The Old Power Station

Proposed Scheme Amendments
January 2024 (updated March 2024)

Railway Warehouse (Block A)

Schedule of Amendments

448.PL.BC.102 E

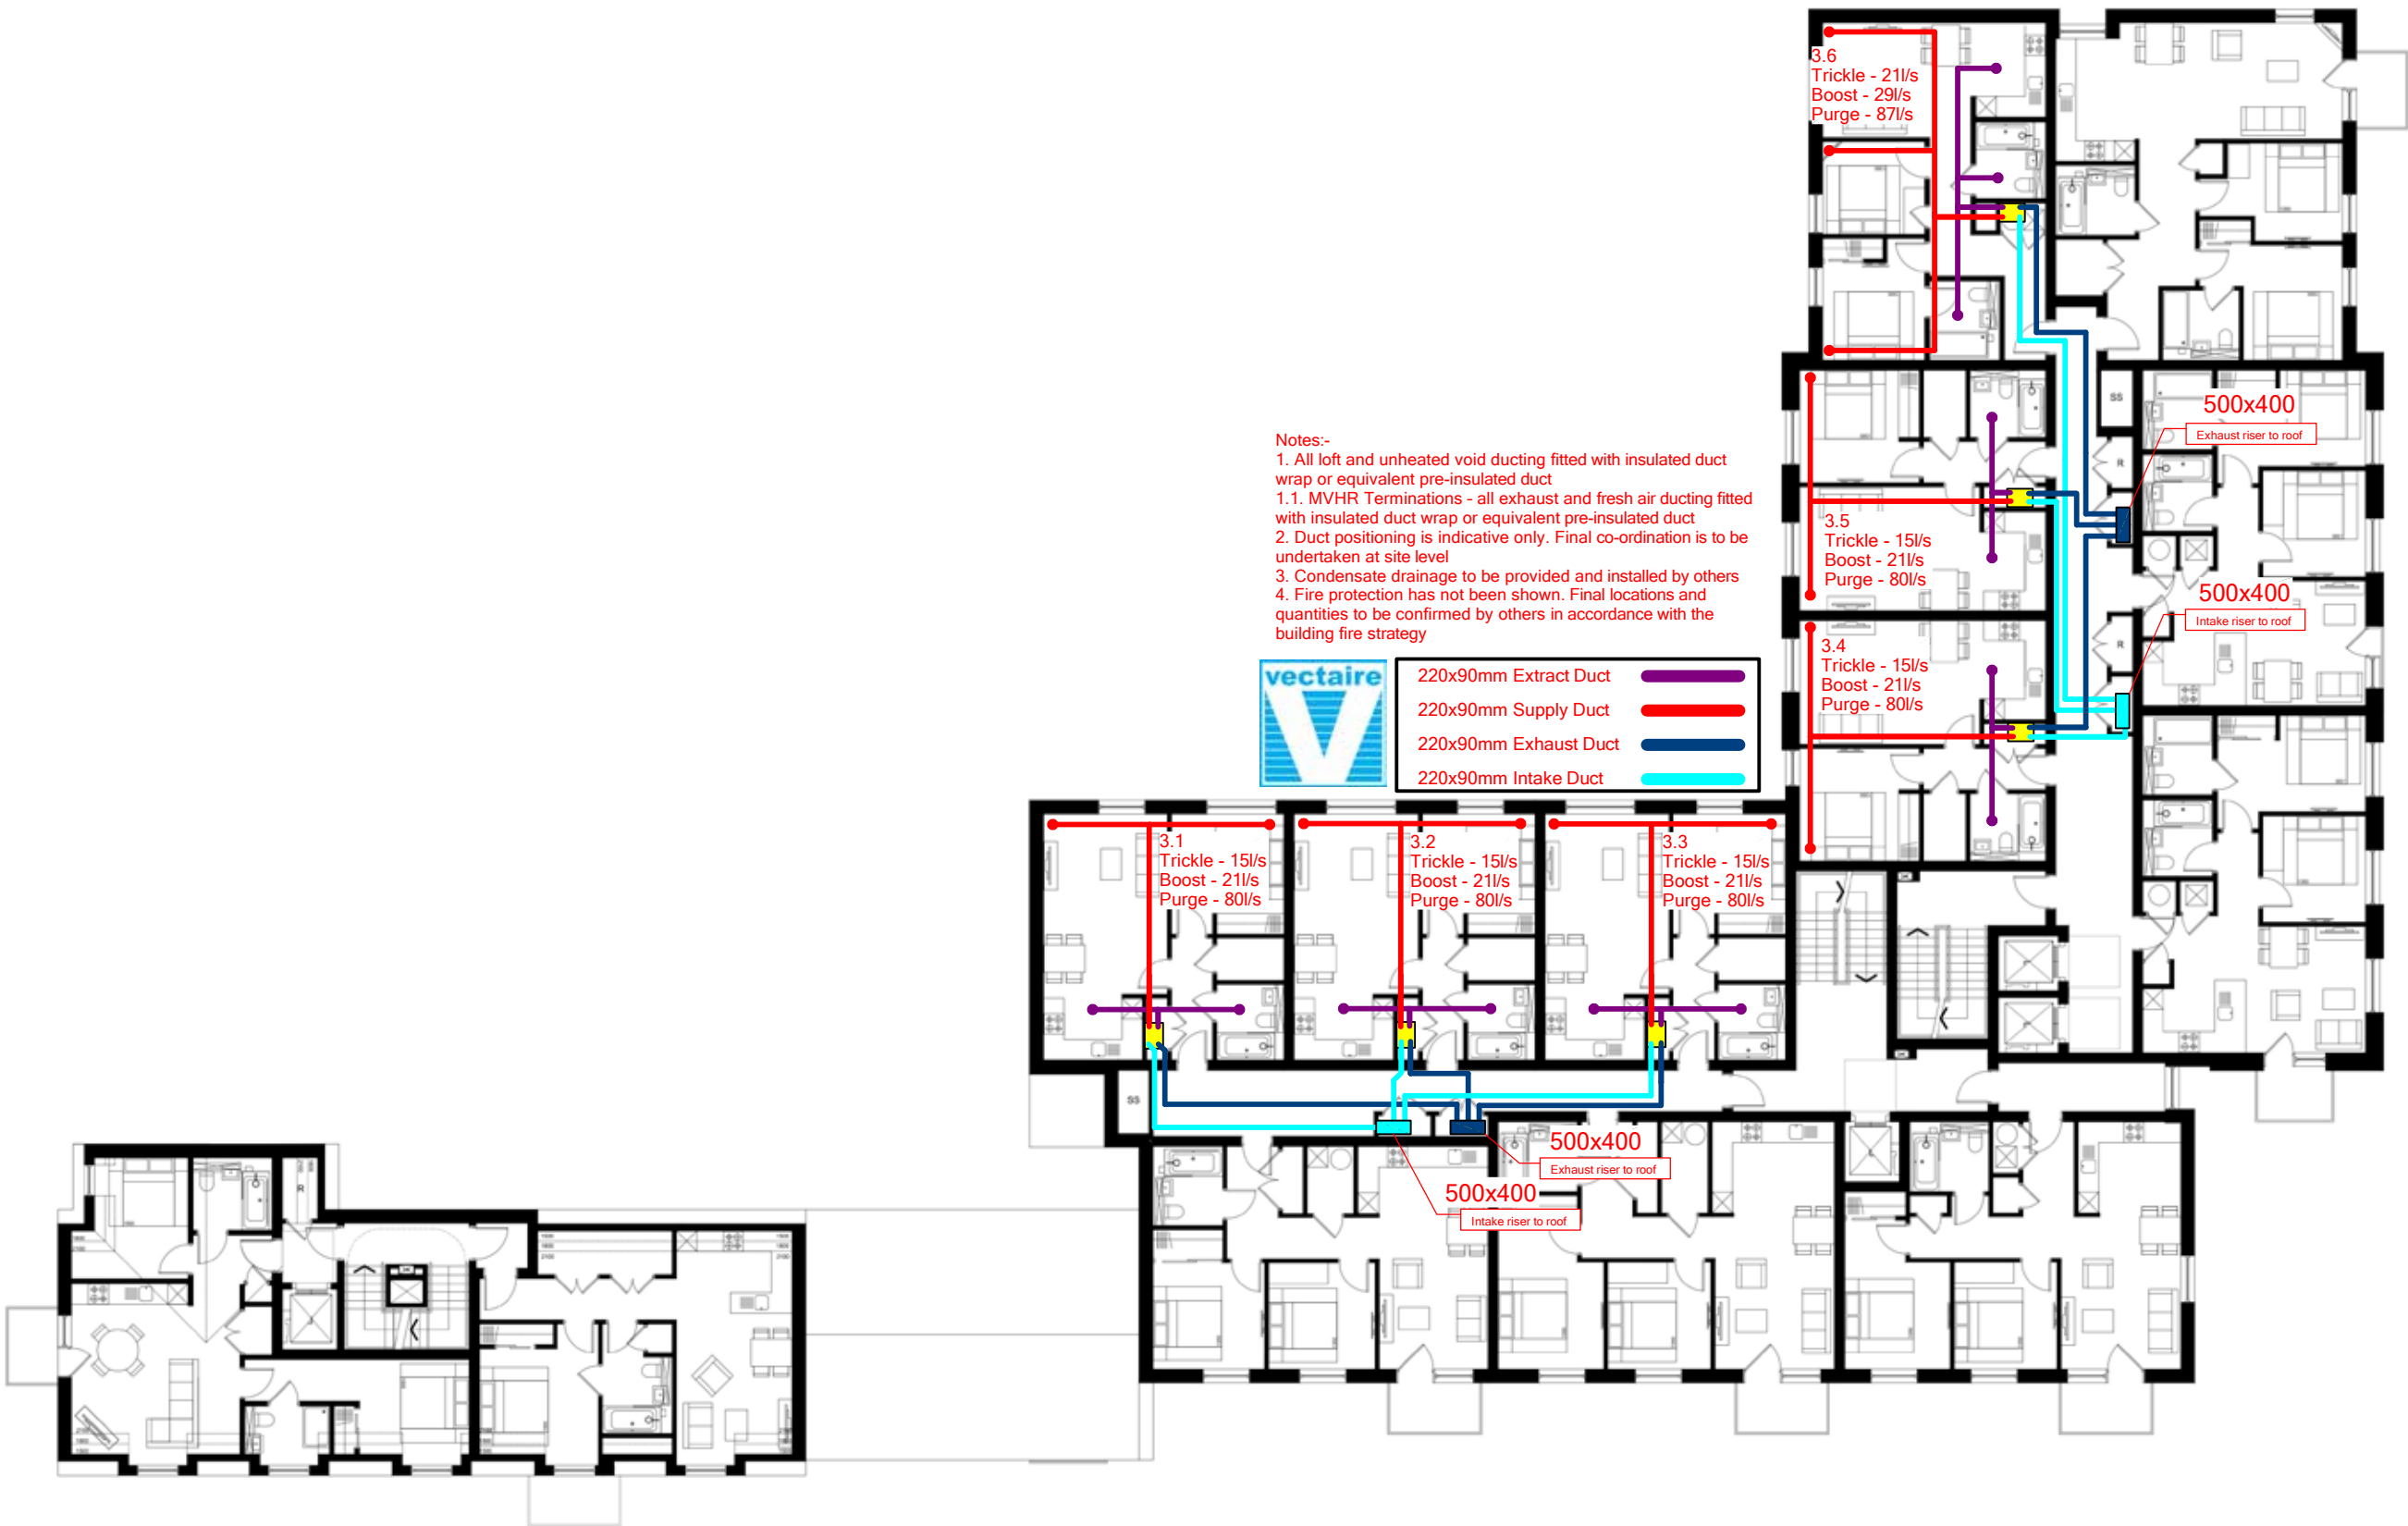
Reference	Description	Justification
B01	Stair configuration changed.	Stair width increased from 1200mm overall width to 1200mm between handrails to reflect fire regulation changes. Stair configuration amended to suit.
B02	Escape door position changed.	Fire escape door and associated internal corridors amended to provide direct escape to external area (planning approved discharged into a vehicle undercroft area) to suit fire regulations.
B03	Entrance door arrangement changed.	Minor amendment to the main entrance door and screen to allow the provision of an on-site management office.
B04	Introduction of second stair and lift core within tallest part of the building.	Second stair core with lift introduced in the tallest part of the building to reflect fire regulation changes to buildings over 18m.
B05	Apartment changed from 2-bed to 1-bed.	Introduction of second stair as noted in B04 reduces the footprint of this apartment and therefore results in a change from 2 bedrooms to 1.

B06	Window changed to fire escape door.	Fire escape door and associated internal corridors introduced to provide direct escape to external area from the new second stair core.
B07	Communal circulation arrangement changed with the introduction of a lift lobby and adjustment to the lengths of corridors serving apartment entrances.	Introduction of a lift lobby between the stairs and corridors with access to apartments in line with fire regulation changes. Corridors serving apartment entrances redesigned to limit distance from apartment entrance to the lift lobby to 7.5m max. to reflect fire regulations (increased travel distances in lower building with introduction of mechanical extract and ventilation system). Riser cupboards amended to suit.
B08	Introduction of new plant rooms.	Larger plant room requirements due to changes in water tank sizes serving the sprinkler systems and introduction of LV switchgear and Emergency LV switchgear to provide dedicated emergency electrical supplies to each block.

B09	Parking spaces reconfigured.	4no parking spaces relocated to reflect changes to the undercroft elements through the alterations to plant room requirements set out in B08.
B10	Cycle store consolidated to a single location.	Cycle store consolidated to a single location due to the introduction of plant rooms and subsequent internal changes.
B11	Refuse store consolidated to a single location.	Refuse store consolidated to a single location due to the introduction of plant rooms and subsequent internal changes. Internal arrangement updated to suit waste officer comments.
B12	Introduction of an on-site management office.	On site management office introduced to serve the development.
B13	Introduction of a single storey.	Introduction of a single storey to provide 6no apartments (3x 1-bed and 3x 2-bed) to offset losses in saleable floorspace through fire changes.
B14	Lift and smoke shaft over-run positions changed and AOV introduced over stairs.	Lift position changed to suit B01 and B04, with smoke shaft position adjusted to suit fire regulations. AOV added to roof plan over stair position for clarity to reflect fire regulation requirements.

B15	Balcony removed.	Balcony removed to reflect internal changes (introduction of stair core).
B16	Access to parking area introduced.	New corridor and access to rear of building introduced to provide more direct routes to refuse, cycles and parking areas from second core.
B17	Combination of 2no. 1-bed to 1no 3-bed.	Apartments combined to maintain policy-compliant number of 3-beds and overall quantum of 209 dwellings.

Reference	Description	Justification
C01	Stair configuration changed.	Stair width increased from 1200mm overall width to 1200mm between handrails to reflect fire regulation changes. Stair configuration amended to suit.
C02	Escape door position changed.	Fire escape door and associated internal corridors amended to provide direct escape to external area to suit fire regulations.
C03	Apartment changed from 2-bed to 1-bed.	Changes to stair, lift, and common circulation as noted in C01 reduces the footprint of this apartment and therefore results in a change from 2 bedrooms to 1.
C04	Communal circulation arrangement changed with the introduction of a lift lobby and adjustment to the lengths of corridors serving apartment entrances.	Introduction of a lift lobby in line with fire regulation changes. Corridors serving apartment entrances redesigned to limit distance from apartment entrance to the lift lobby to 7.5m max. to reflect fire regulations. Riser cupboards amended to suit.

C05	Introduction of sub station, reconfiguration of refuse and cycle stores to suit.	Sub station required due to increased electrical demands in part due to increased electric car charging facilities. Refuse store internal arrangement updated to suit waste officer comments.
C06	Extent of flat roof increased.	Area of flat roof on the rear elevation increased to suit internal changes noted in C04.
B18	AOD levels updated.	AOD levels for plant over-run to roof-tops updated to suit required offset from closest roof obsticals and required offset from ceiling of top floor.
